PROJECT:  
LEXINGTON LOFTS  
200 BOLIVAR STREET  
LEXINGTON, KENTUCKY  
DRAWING:  
SECOND FLOOR PLAN

SHEET NO.  
**A-3**

**AS-BUILT DRAWING 8/25/04**

**SECOND FLOOR PLAN**  
SCALE: 1/8" = 1'-0"  
41,500 SQUARE FEET (GROSS)

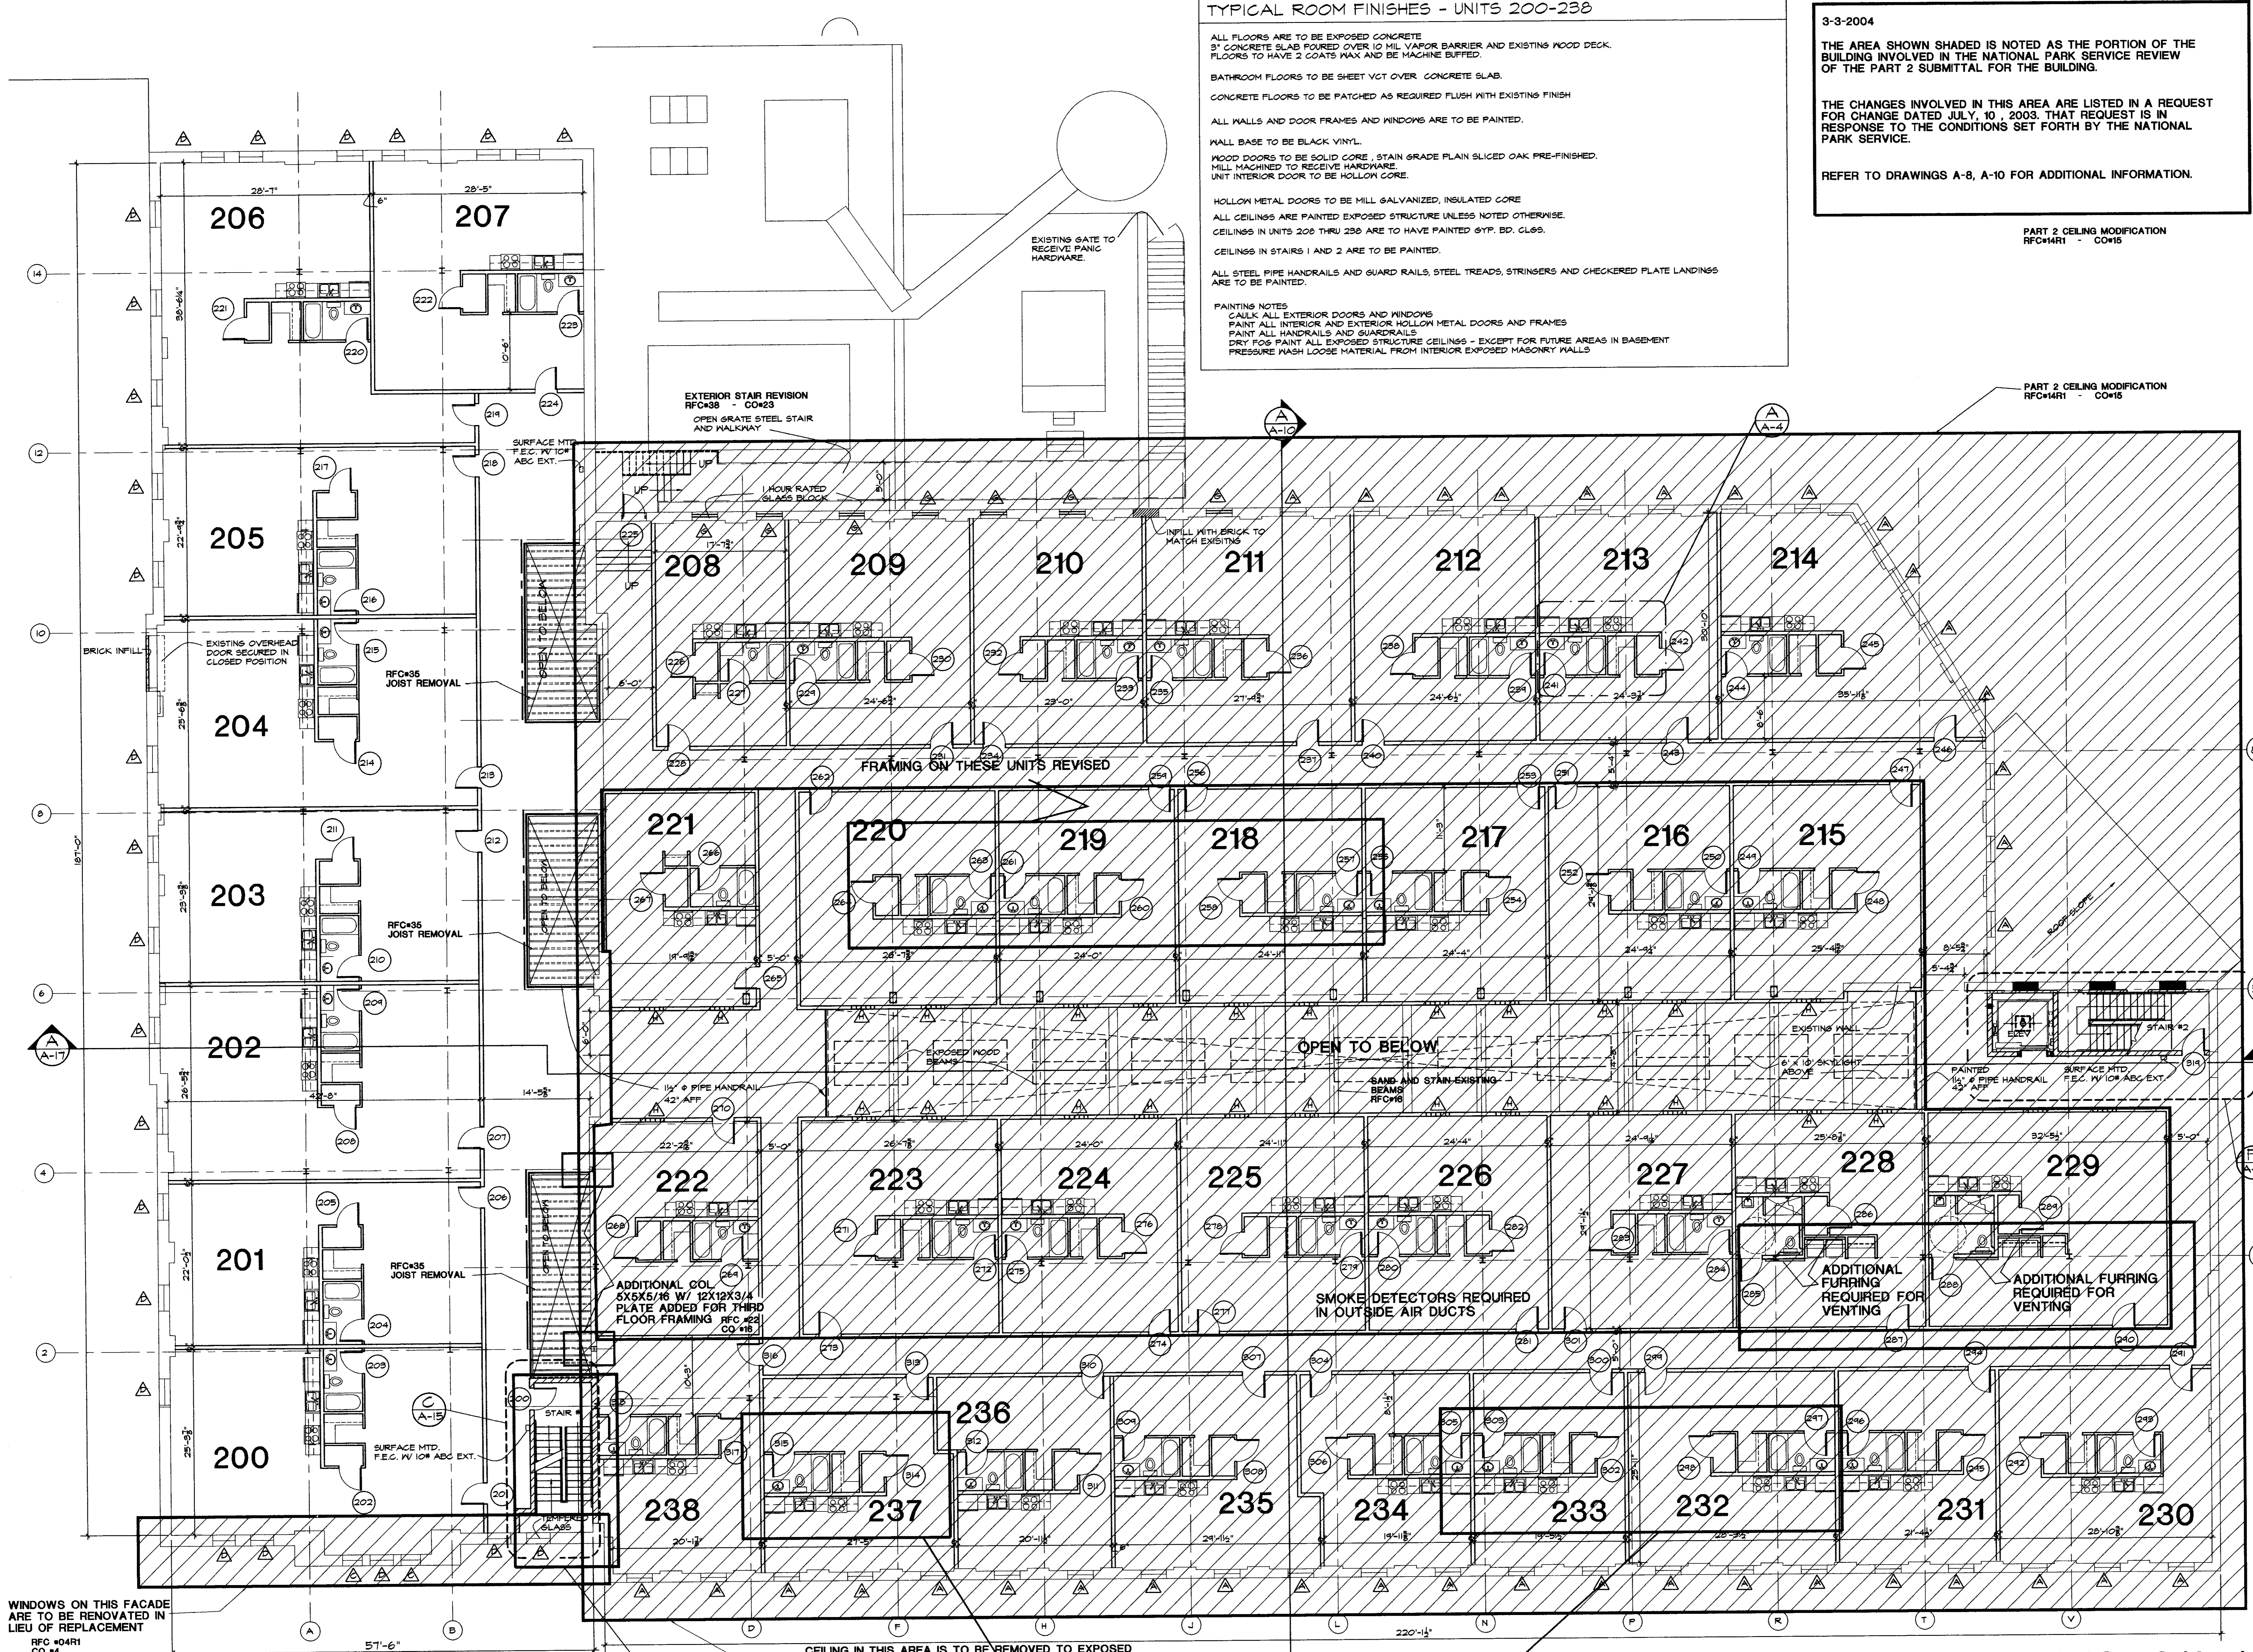
THE AREA SHOWN SHADED IS NOTED AS THE PORTION OF THE BUILDING INVOLVED IN THE NATIONAL PARK SERVICE REVIEW OF THE PART 2 SUBMITTAL FOR THE BUILDING.

THE CHANGES INVOLVED IN THIS AREA ARE LISTED IN A REQUEST FOR CHANGE DATED JULY, 10, 2003. THAT REQUEST IS IN RESPONSE TO THE CONDITIONS SET FORTH BY THE NATIONAL PARK SERVICE.

WINDOWS ON THIS FACADE ARE TO BE RENOVATED IN LIEU OF REPLACEMENT  
RFC #04R1  
CO #4

CEILING IN THIS AREA IS TO BE REMOVED TO EXPOSED EXISTING STRUCTURE.  
RFC #14R1  
CO #15

SEE SHEETS A-11 AND A-15 FOR STAIR #1 REVISIONS  
RFC #23  
CO #17

FRAMING ON THESE UNITS REVISED
